Florida Power and Light Company  
Turkey Point Plant  
Unit No. 3  
Docket Number 50-250

REACTOR CONTAINMENT BUILDING  
INTEGRATED LEAKAGE RATE TEST  
MARCH 20, 1979

V. OPERATING PROCEDURE 13100.1 #3 ILRT MASTER COPY

OPERATING PROCEDURE 13100.1, PAGE 26  
INTEGRATED LEAK RATE TESTAPPENDIX B

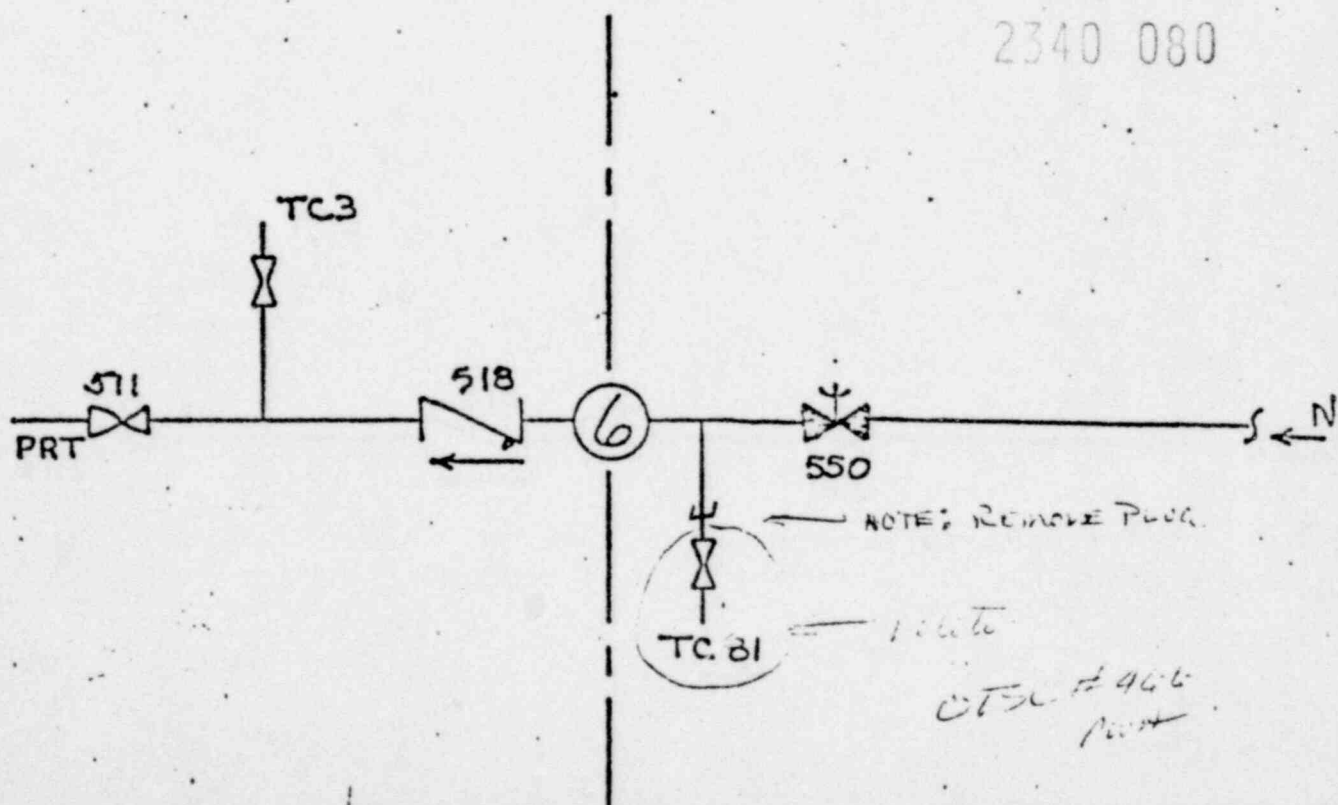
1 Pg 26 - PEN 6 - DELETE VLV. AT TC81. ADD NOTE "REMOVE PLUG."

1 Pg 26 - PEN 6 - CORRECT DRAWING TO REFLECT "AS-IS" CONDITION.

OPERATING PROCEDURE 13100.1, PAGE 30  
INTEGRATED LEAK RATE TEST

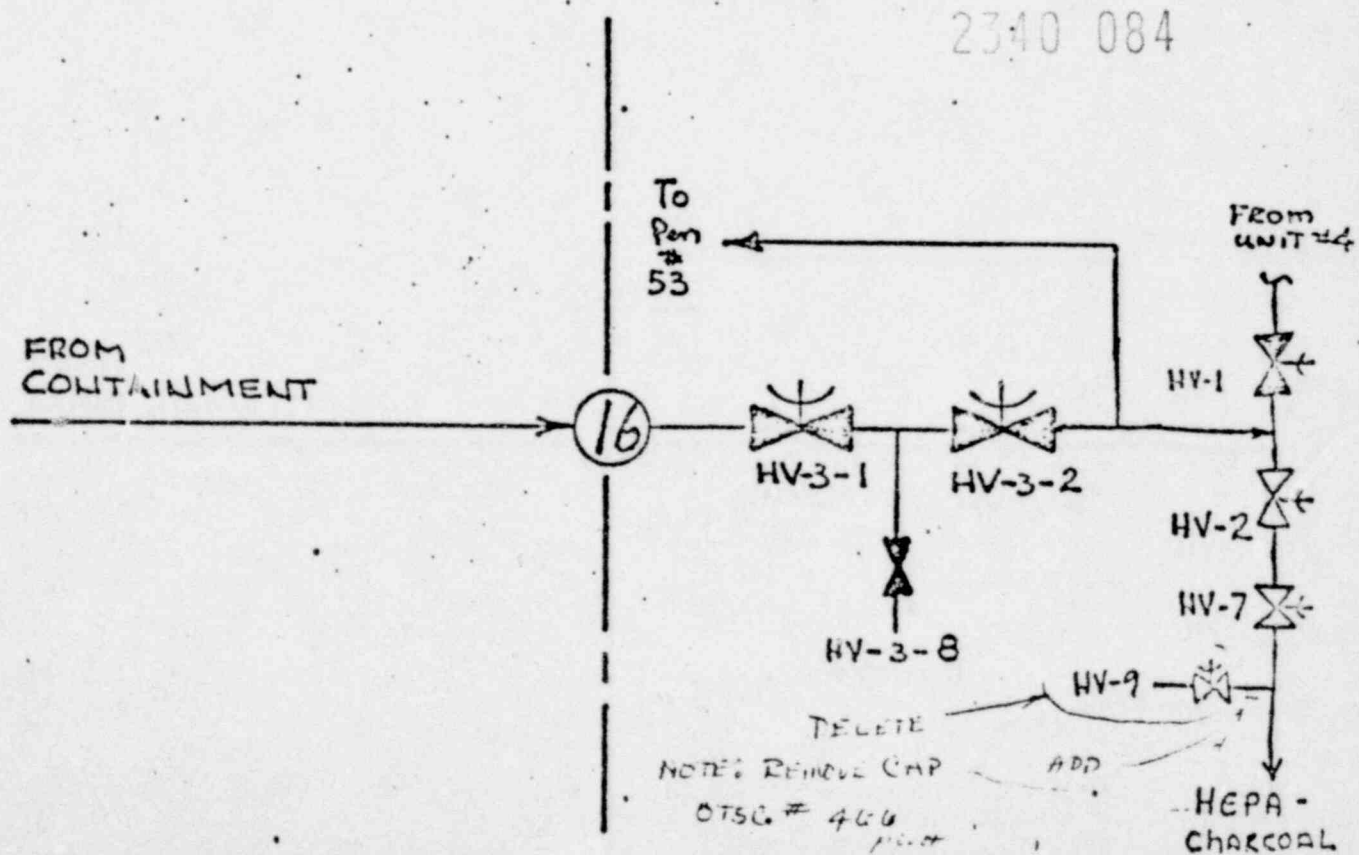
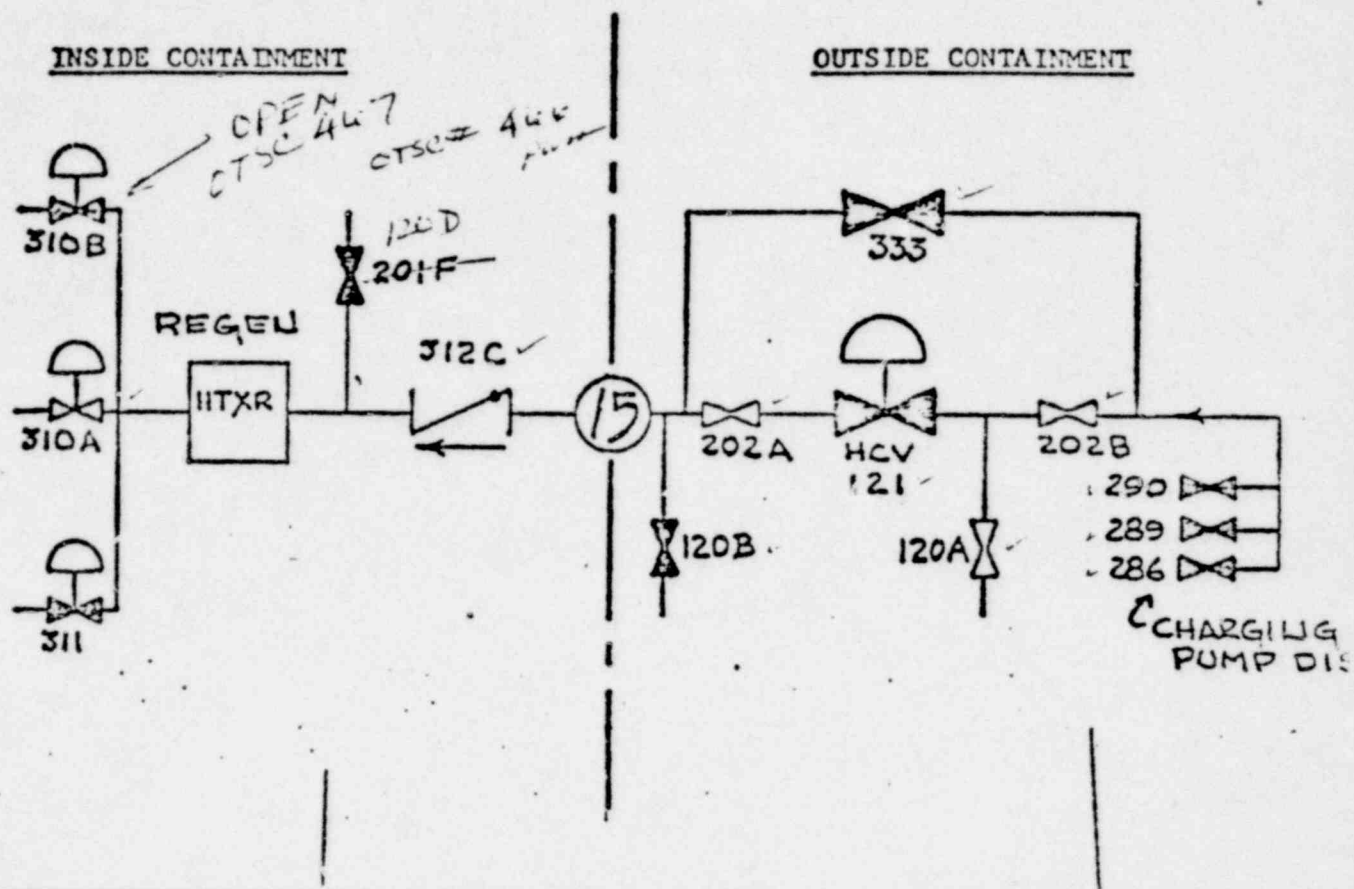
2 Pg 30 - PEN 15 - CHANGE VLV. # FROM 201F TO 126D

3 Pg 30 - PEN 16 - DELETE VLV. # LINE FROM HV-9. ADD NOTE "REMOVE CAP." ✓

2 Pg 30 - PEN 15 - CORRECT ERROR.

3 Pg 30 - PEN 16 - CORRECT DRAWING TO REFLECT "AS-IS" CONDITION.

OPERATING PROCEDURE 13100.1, PAGE 34  
INTEGRATED LEAK RATE TEST

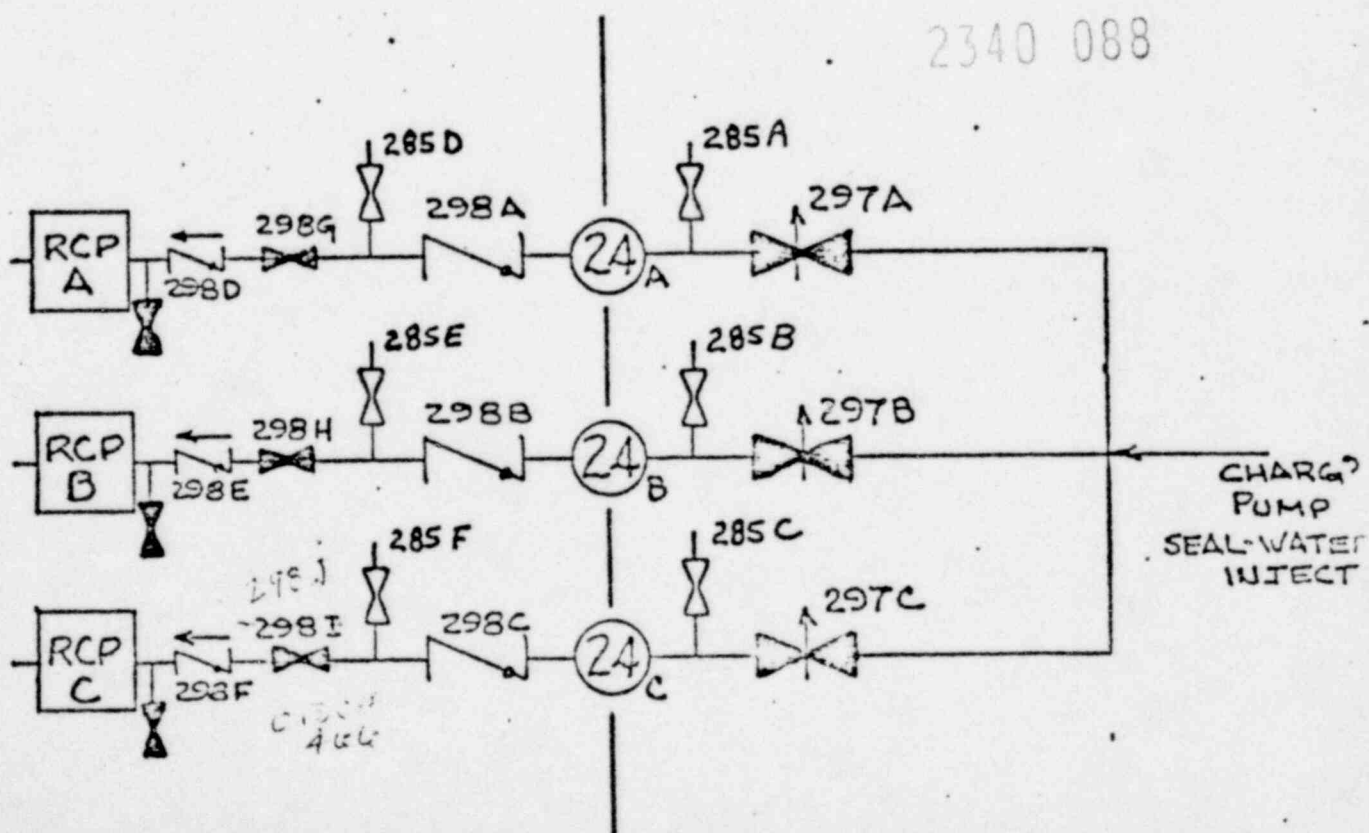
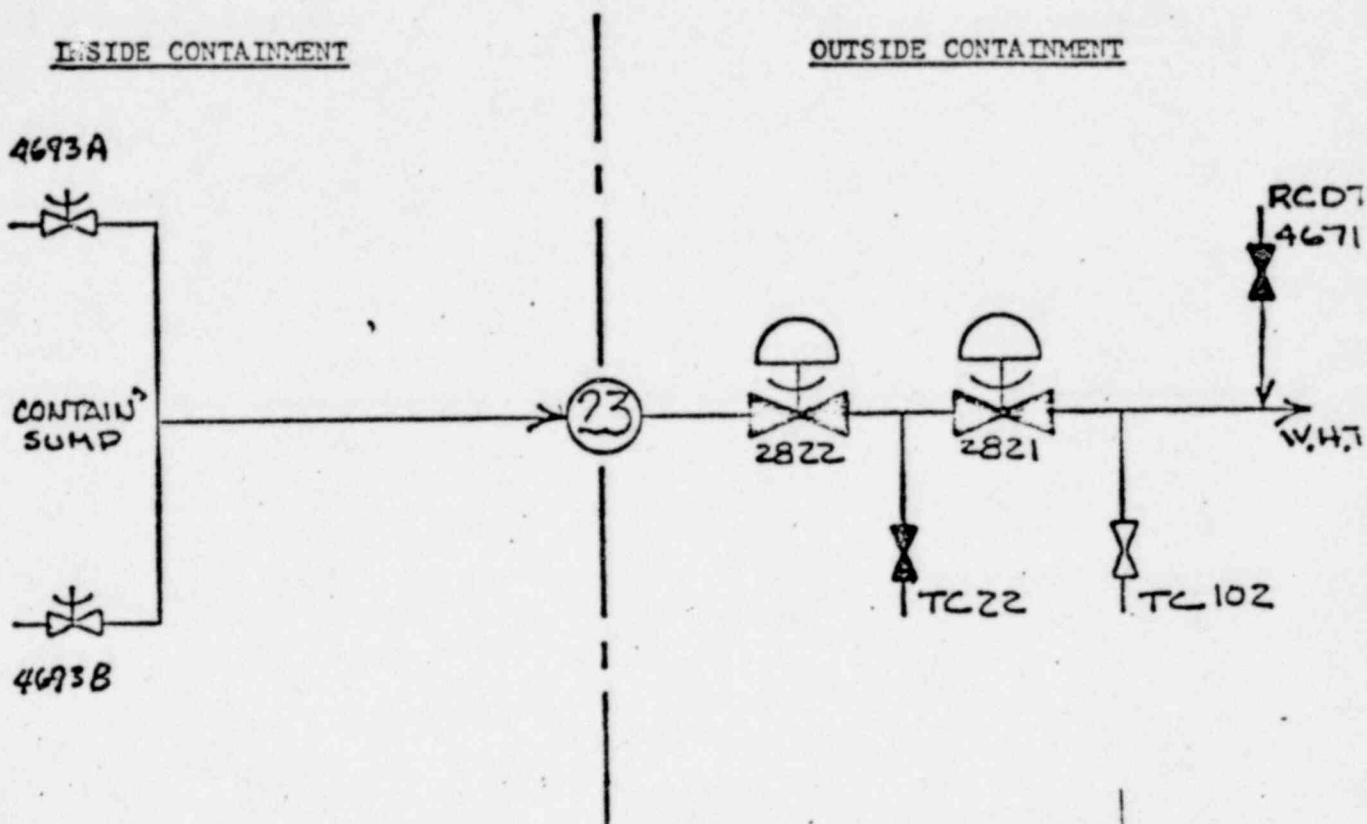
(14) Pg 34 - PEN. 24C - CHANGE VLV. # 298 I TO 298 J
